STATE OF CONNECTICUT
CONNECTICUT SITING COUNCIL

APPLICATION OF CELLCO PARTNERSHIP)	
d/b/a VERIZON WIRELESS FOR A)	
CERTIFICATE OF ENVIRONMENTAL)	DOCKET NO. 413
COMPATIBILITY AND PUBLIC NEED FOR THE)	
CONSTRUCTION, MAINTENANCE, AND)	
OPERATION OF A WIRELESS)	April 14, 2011
TELECOMMUNICATIONS FACILITY LOCATED AT)	
723 LEETES ISLAND ROAD IN THE TOWN)	
OF BRANFORD, CONNECTICUT)

NEW CINGULAR WIRELESS PCS, LLC ("AT&T")
RESPONSES TO TOWN OF BRANFORD INTERROGATORIES

ATTACHMENT 4

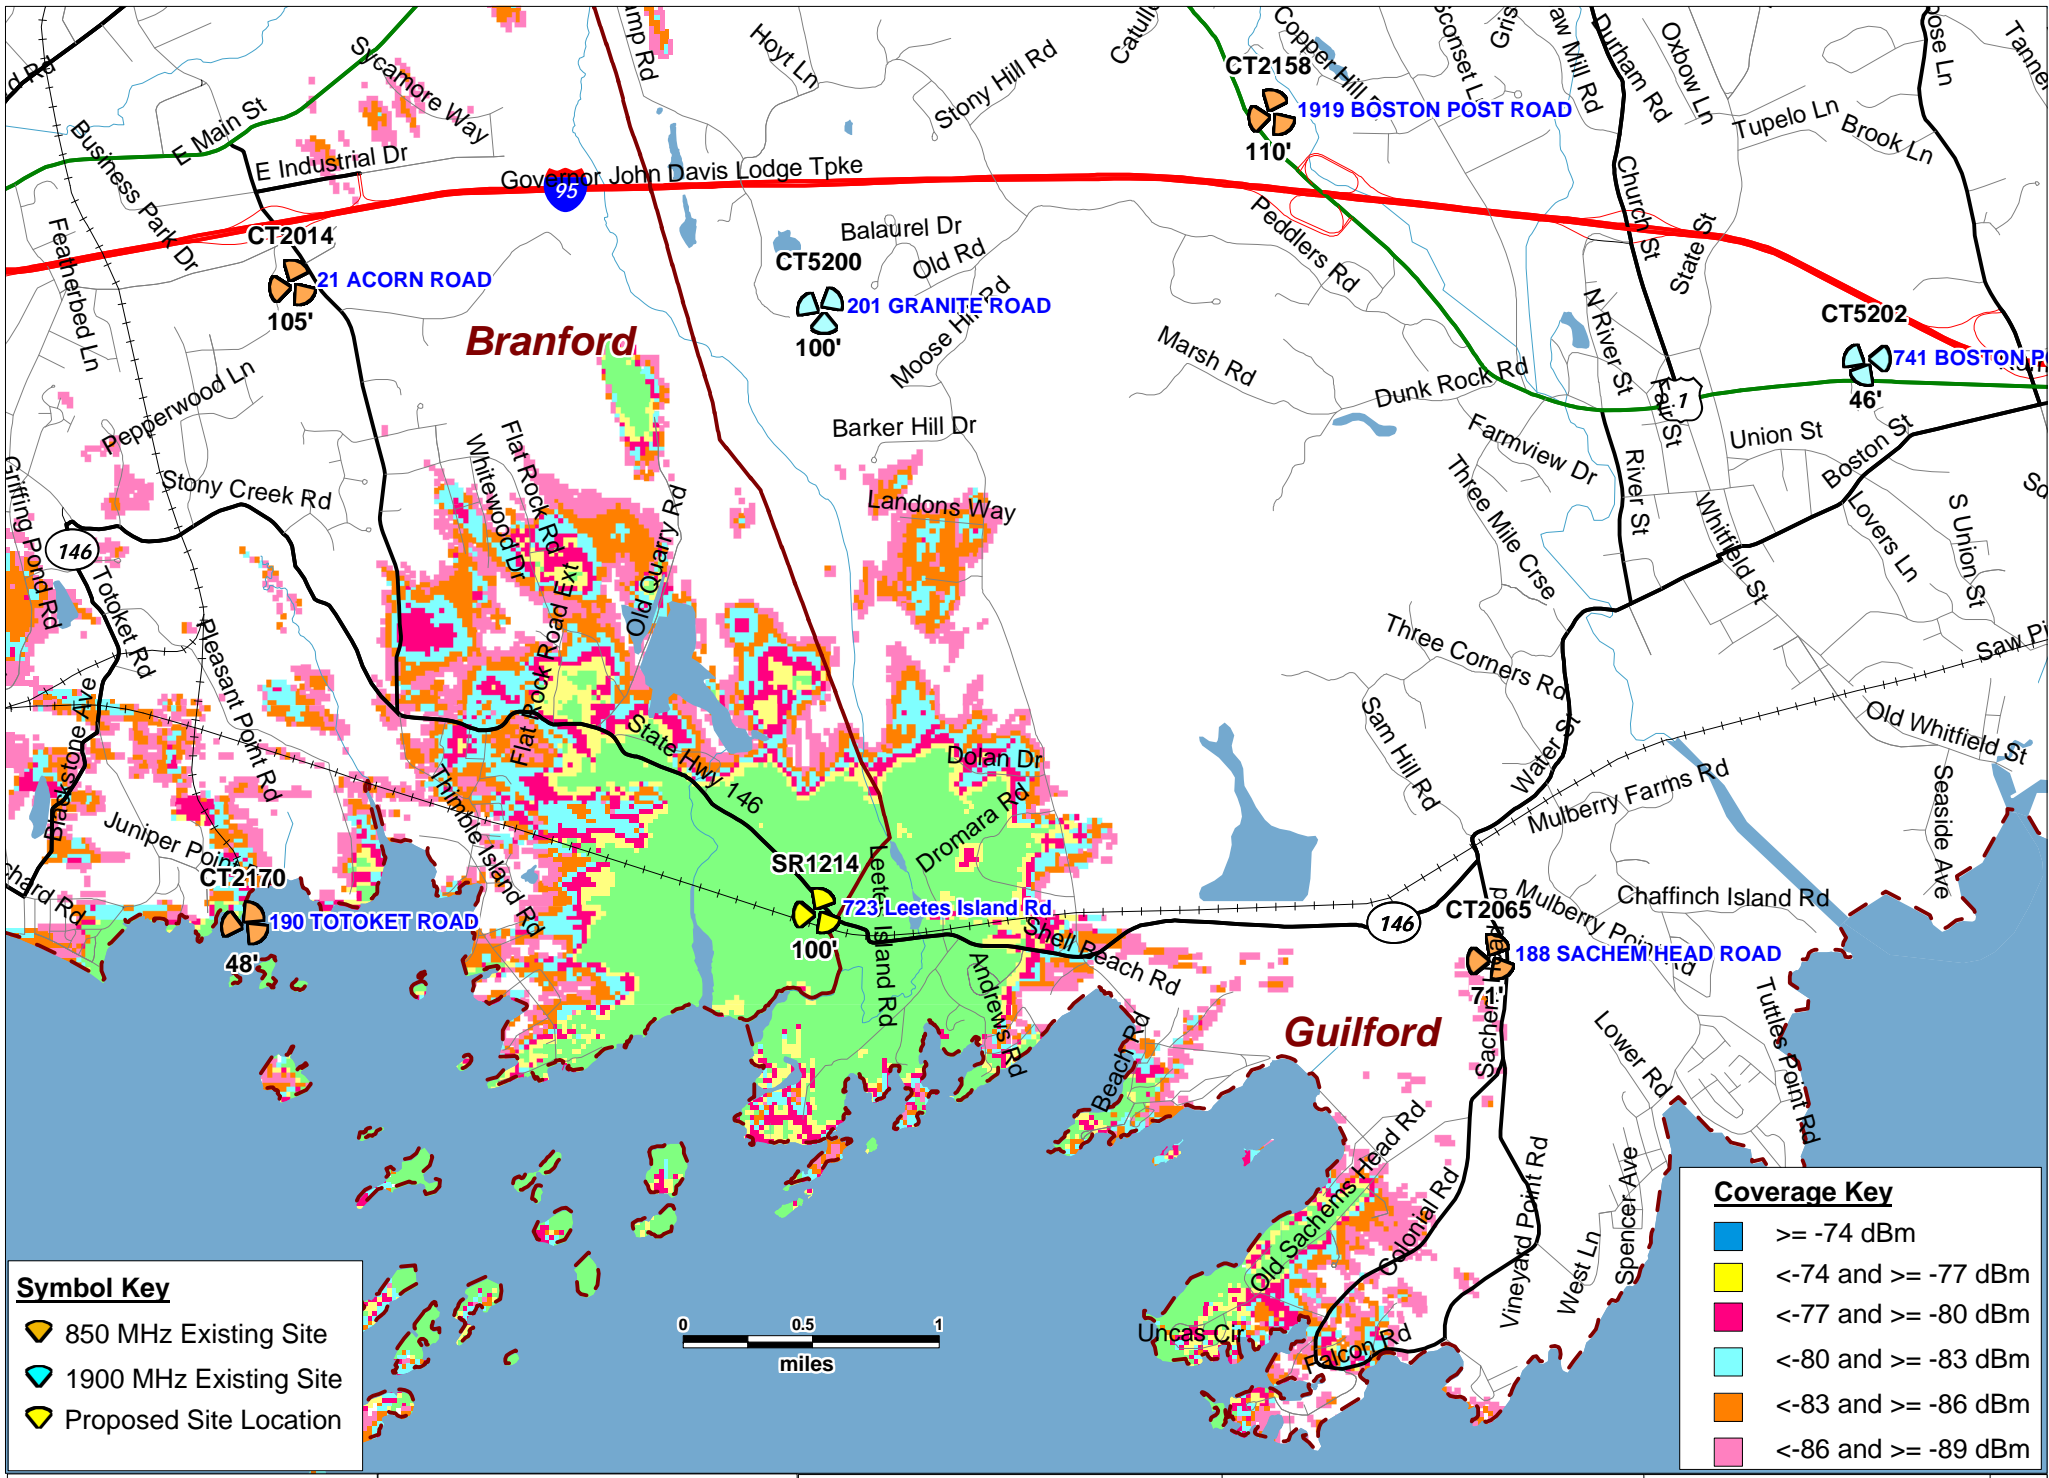
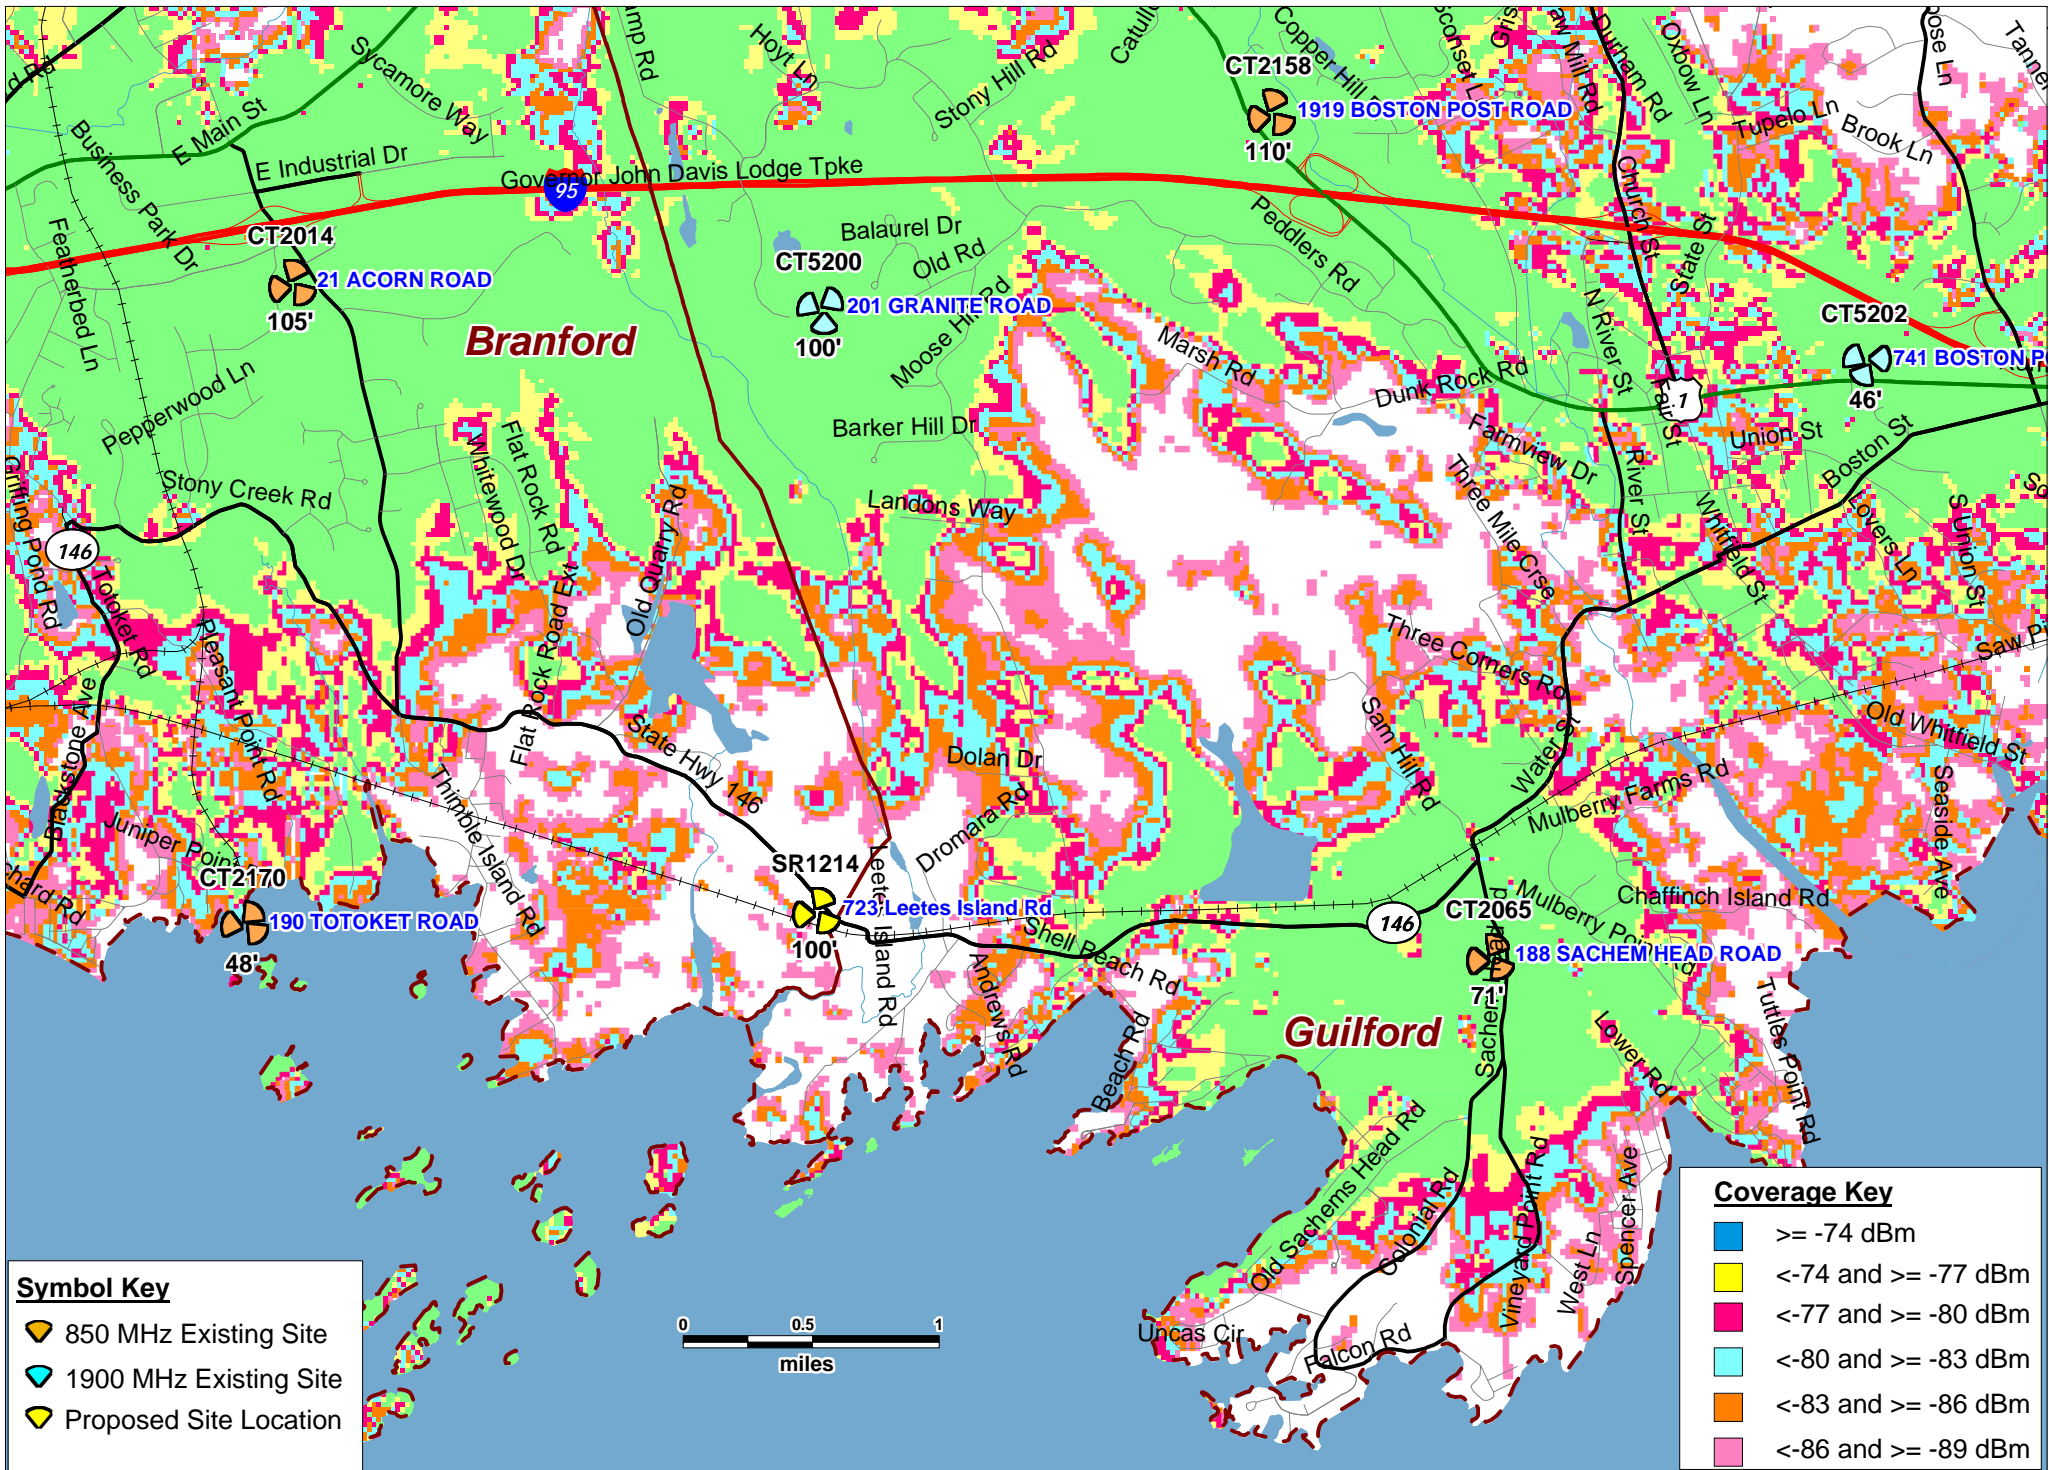
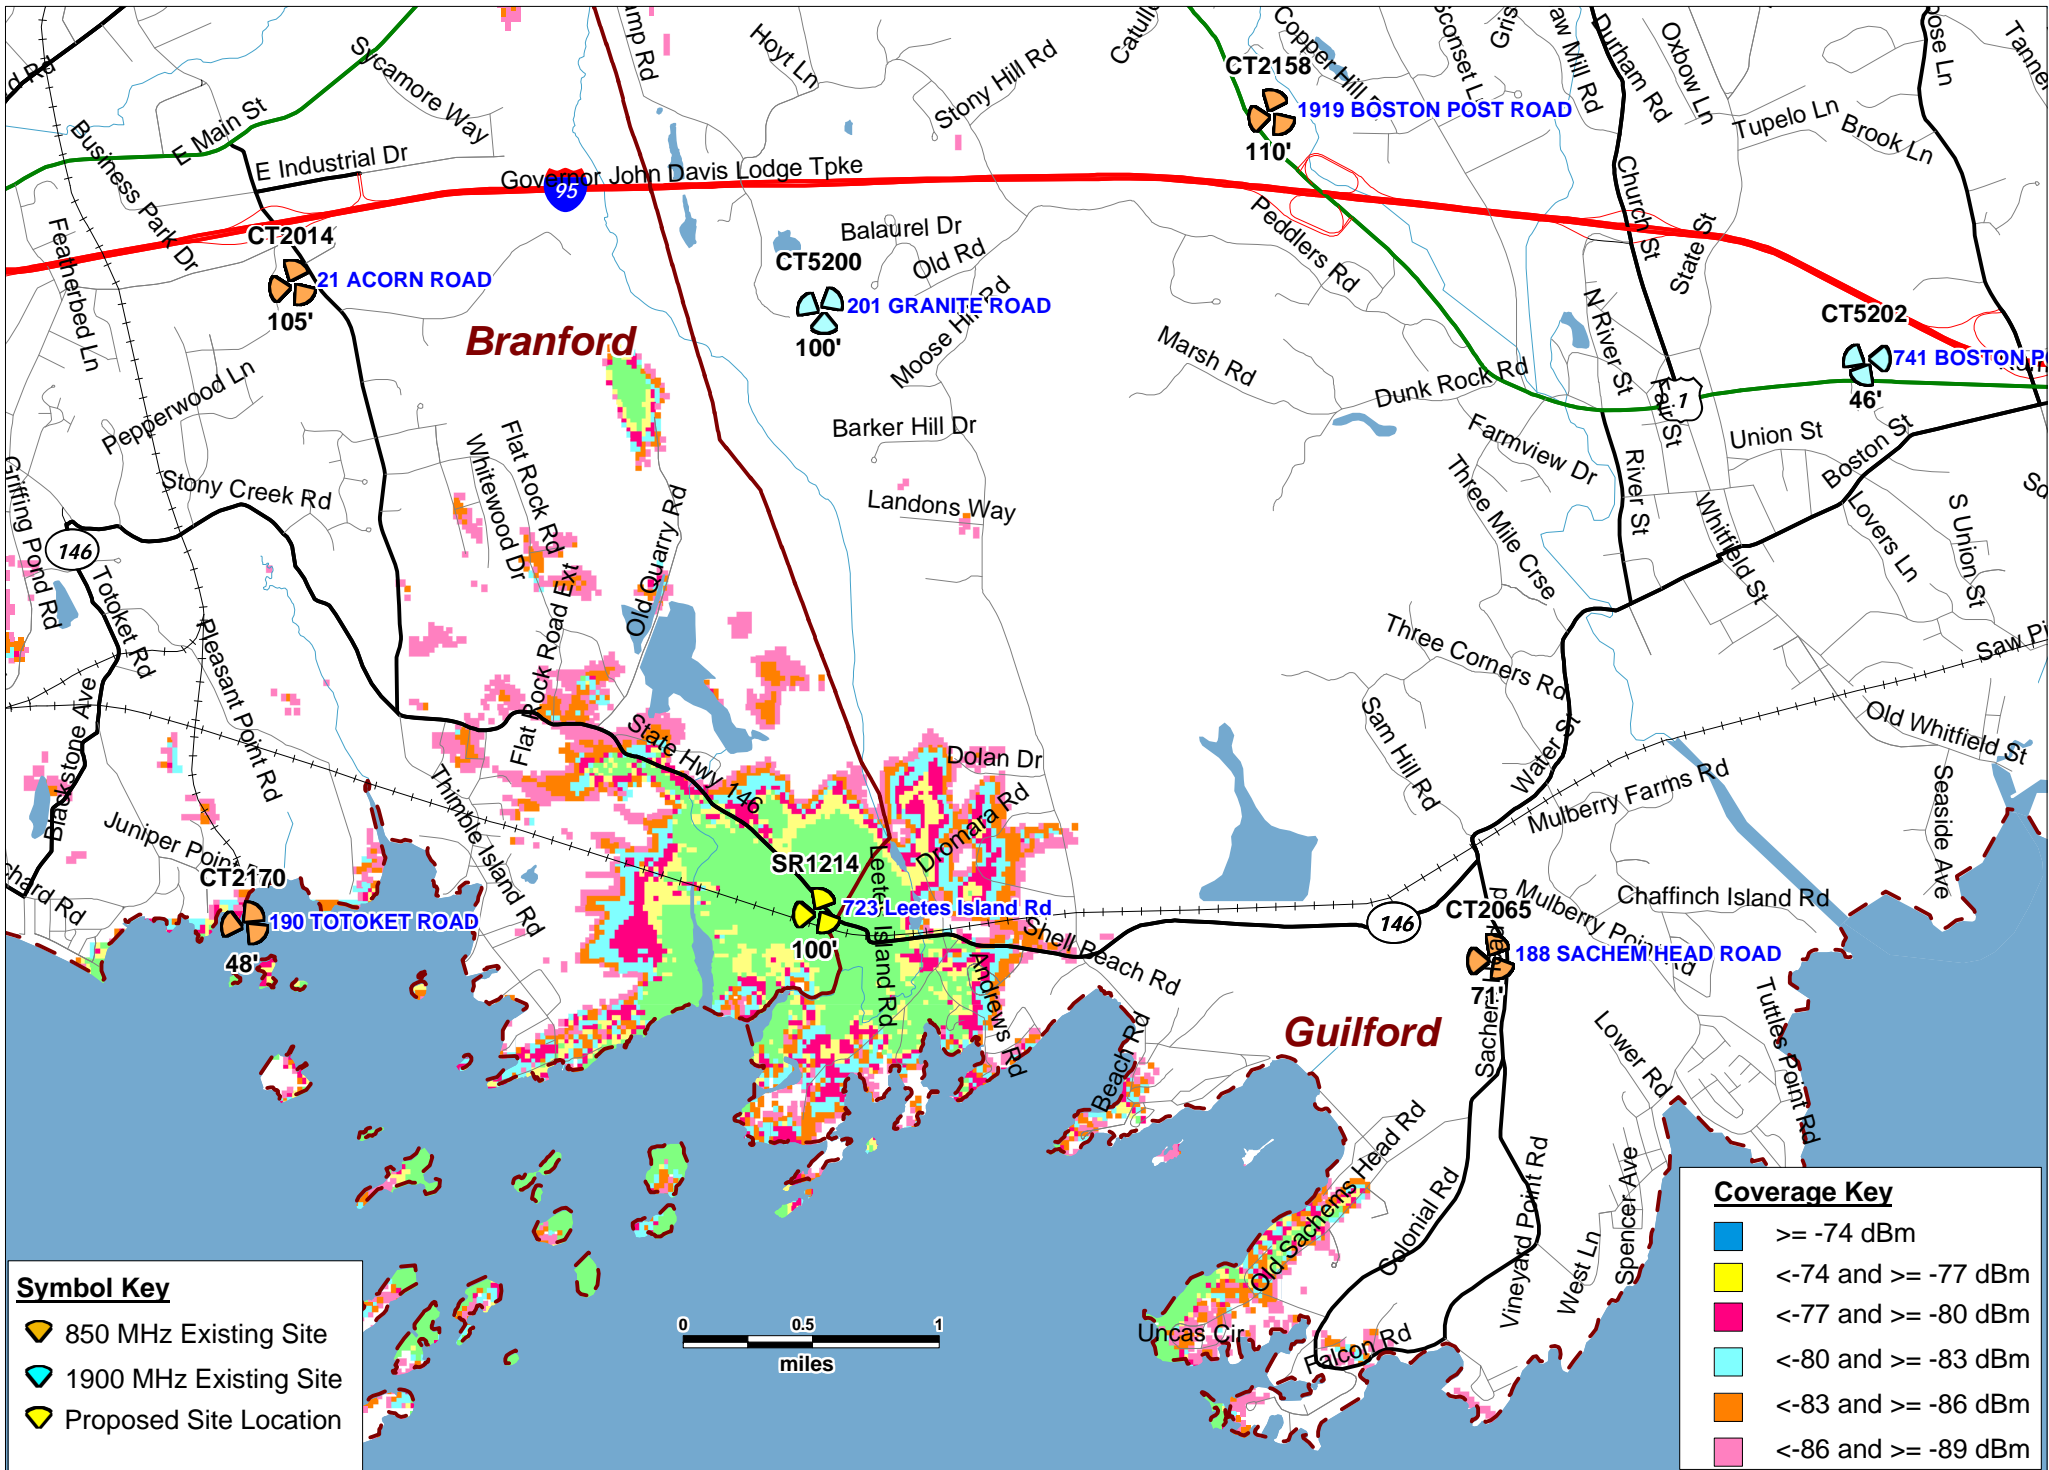
A34. Can you provide separate proposed and existing coverage maps depicting the coverage from the target levels up to -88dBm with the levels at -3dBm intervals (e.g.: -74 to -77dBm, -77dBm to -80dBm, etc)?

A34. The requested plots are included in Attachment 4.
